REQUEST FOR TECHNICAL CHANGE

AGENCY: Building Code Council

In reviewing this Rule, the staff recommends the following technical changes be made:

FIGURE R703.8.2.1
EXTERIOR MASONRY VENEER SUPPORT BY STEEL ANGLES
Permanent Rule 0400 – 03/2019

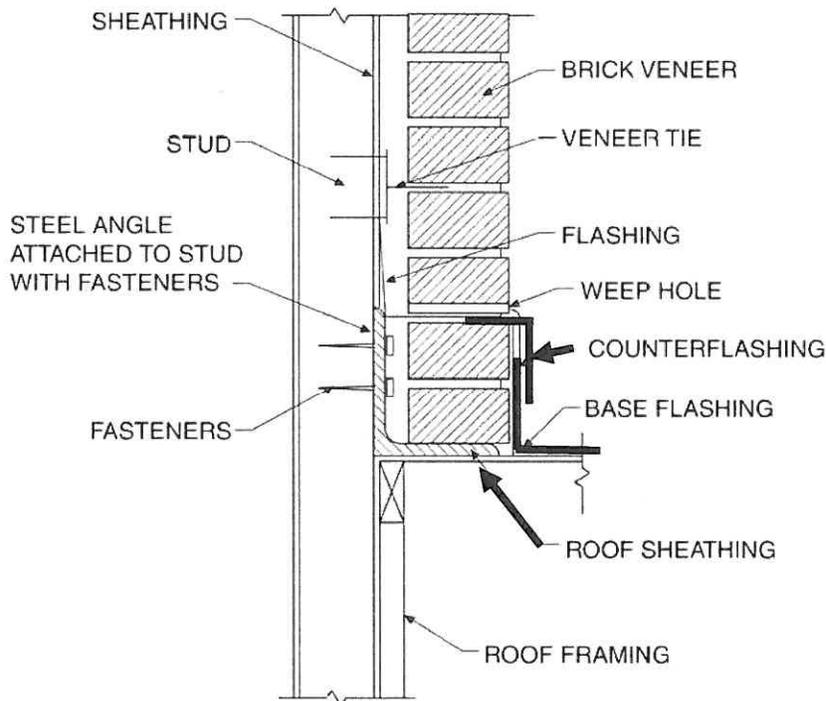
Figure R703.8.2.1: So that I’m clear – is the only change to this Figure to make the lines for counter flashing and base flashing bold? And should “counter flashing” be two words?

From what you published, it appears that you intended to add language under “Fasteners” to state “per R703.8.2.1” Did the agency decide to not make this change?

FIGURE R703.8.2.2
EXTERIOR MASONRY VENEER SUPPORT BY ROOF MEMBER

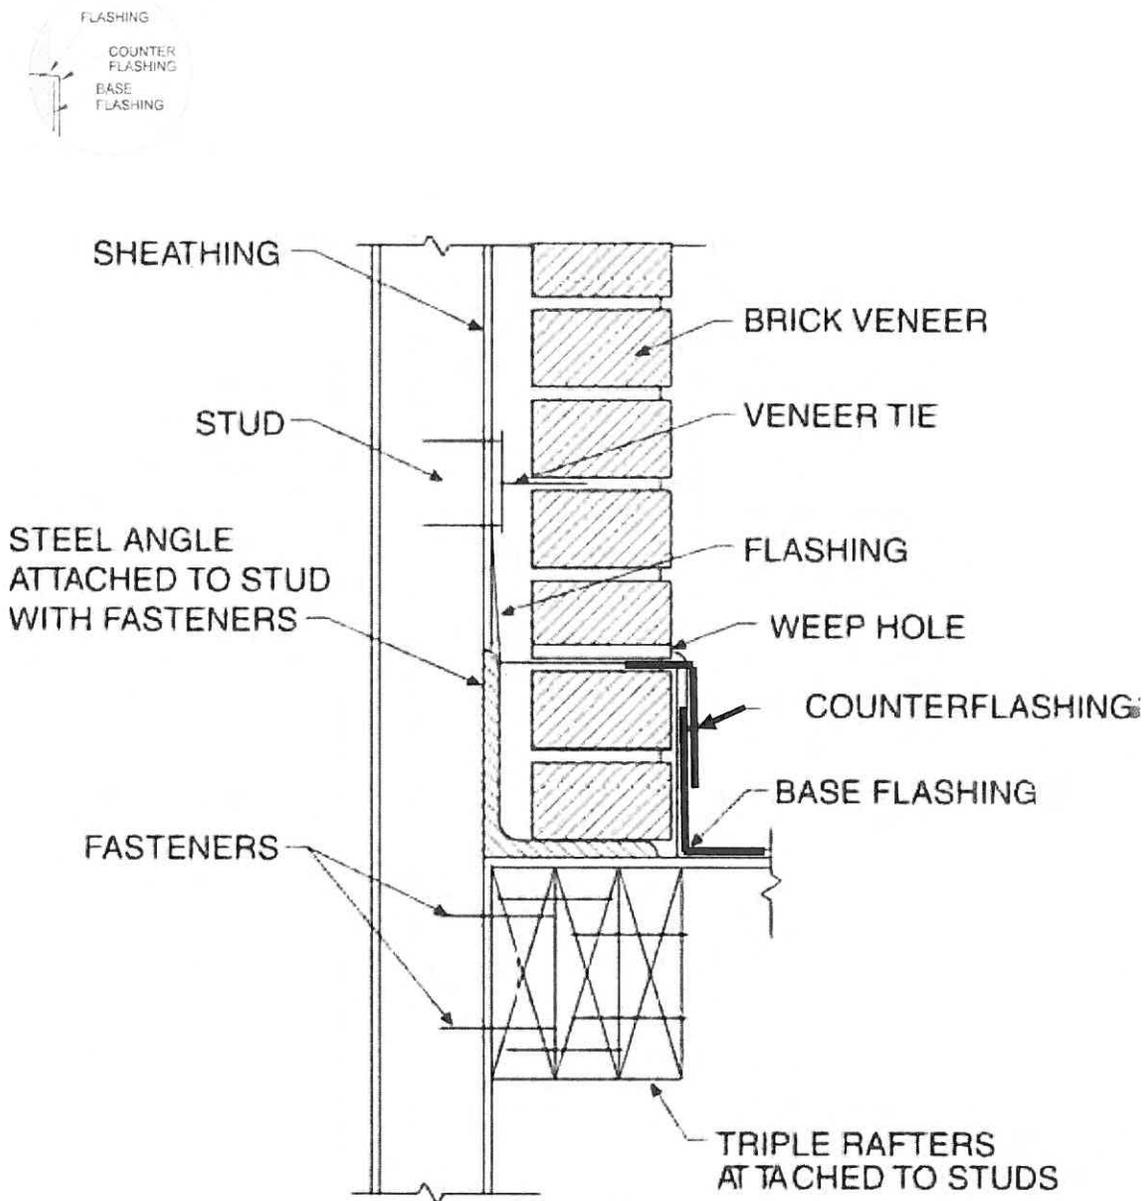
Figure R703.8.2.2: So that I’m clear – is the only change to this Figure to make the lines for counter flashing and base flashing bold? And should “counter flashing” be two words?

From what you published, it appears that you intended to add language under “Fasteners” to state “per R703.8.2.1” Did the agency decide to not make this change?
